Elevated View 237 Spring St. Revised egress window proposal/estimate. 7/21/15

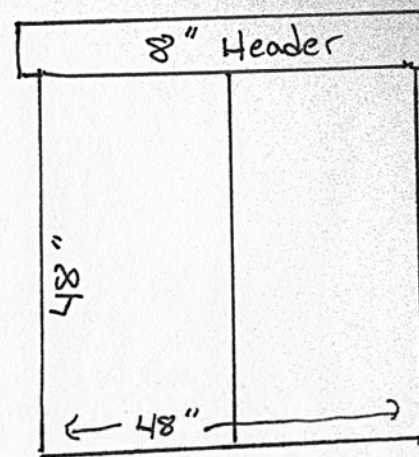
State Fire Marshal Requirements:

- 5.7 sq ft clearance egress opening
- Minimum 24" up from floor.

Stairs to be rebuilt to meet uniform riser/tread requirements. Handrails to be added per Portland Inspection division request.
